ADDENDUM No. 5

REQUEST FOR QUOTATION No.: 1220-040-2021-005

TITLE: BUILDING DEMOLITION AND HAZARDOUS MATERIAL REMOVAL 6965 KING GEORGE BOULEVARD

ADDENDUM ISSUE DATE: JANUARY 11, 2021

Attachment 1 – Figure 5

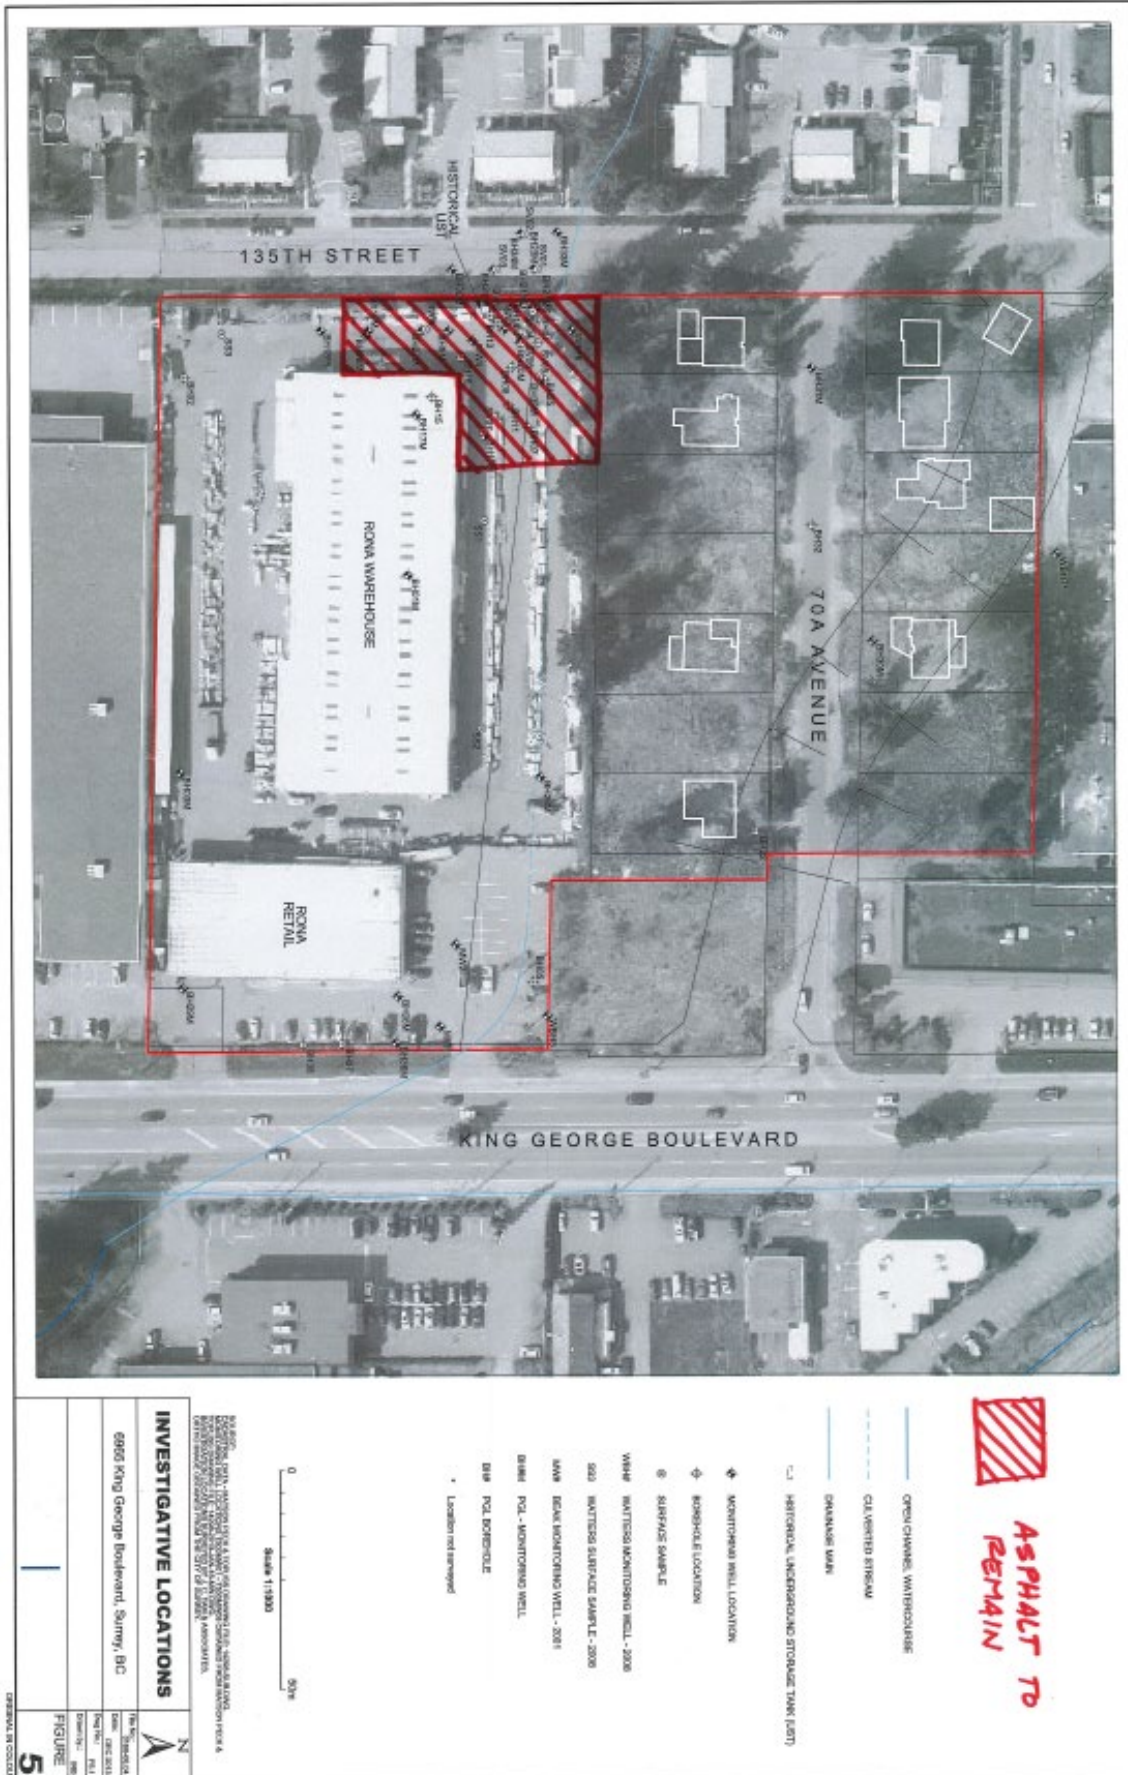
- Refer to Attachment 1 – Figure 5: The highlighted portion indicates the area of asphalt that should be left in place for the current environmental investigation. All wells in the north west corner of the site will be needed for the current investigation.

Attachment 2 – Figure 2

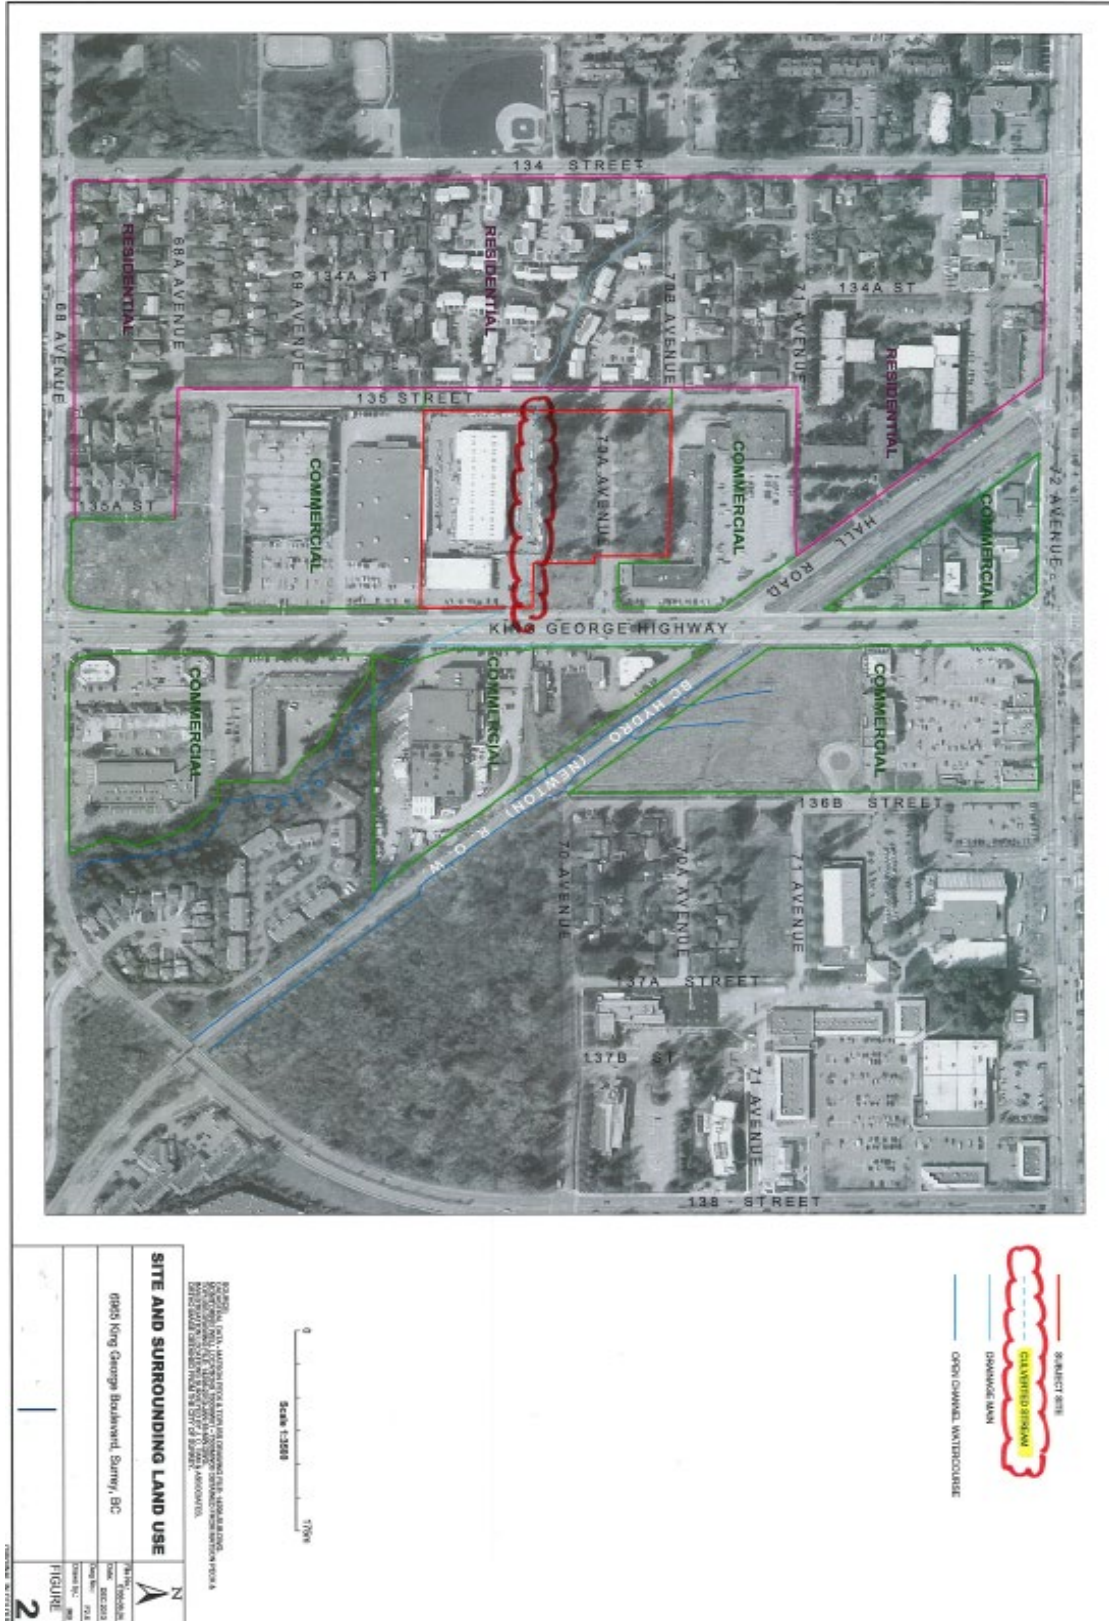
- Refer to Attachment 2 – Figure 2:
 - Erosion and Sediment Control (ESC) permit will be required for the site by the contractor as it is over 2000 m². Measures should be included to retain water on site per the ESC designer (retained by contractor).
 - Existing infrastructure for culverted stream to remain in place. Refer to attached map (Figure 2) highlighting location.
